Technical Service Bulletin

37 Transmission malfunction, DTC P17F600, U008000, and/or U010100 stored in TCM or ECM

37 19 84 2053878/1 February 26, 2019.

Model(s)	Year	VIN Range	Vehicle-Specific Equipment
A6, A7	2019	000001 - 050600	3.0 TFSI

Figure 5. Routing and wrapping of the aft part of the transmission harness.

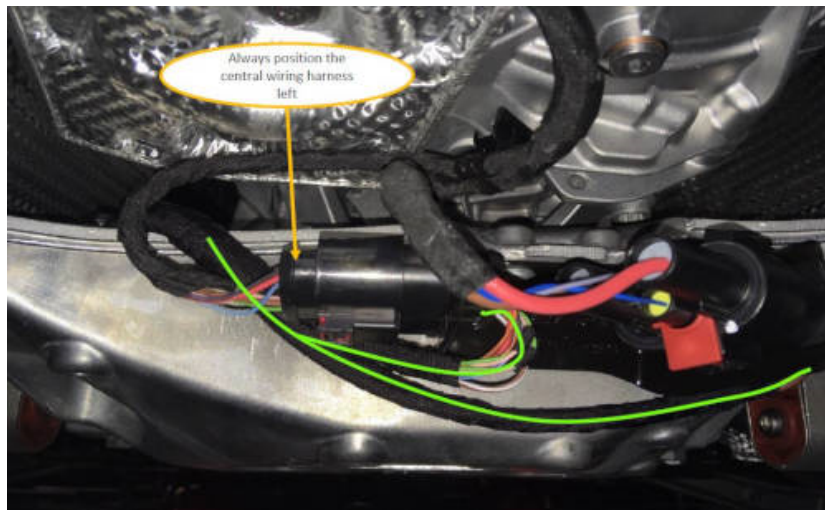
2. Replace and reroute the transmission harness.
 - Remove the old transmission harness in the vehicle.
 - Wrap the exposed wires in the transmission harness as shown in Figure 5.
 - Mount and route the new transmission harness as shown in Figure 6.
